Watershed Management Program for Santa Monica Bay Jurisdictional Group 7 within the City of Los Angeles

SMB JG7 WMP Group Overview

Comments Received from RB

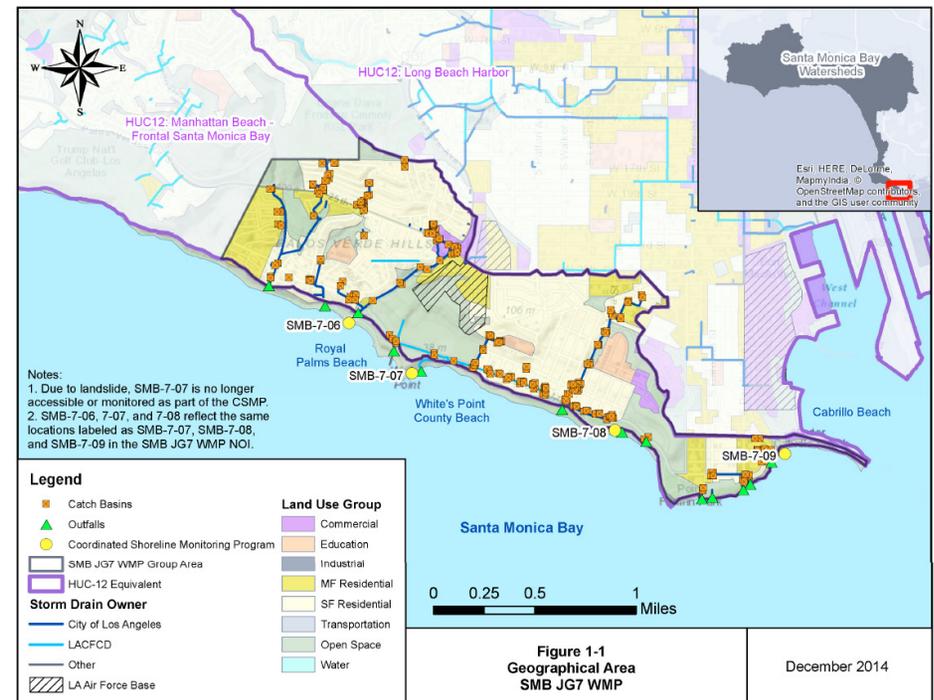
1) Include Point Fermin sub-watershed

- *Point Fermin Park Beach sub-watershed added*
- *Expanded the geographical area to 1056 acres*
- *Included SMB 7-09 shoreline monitoring station*
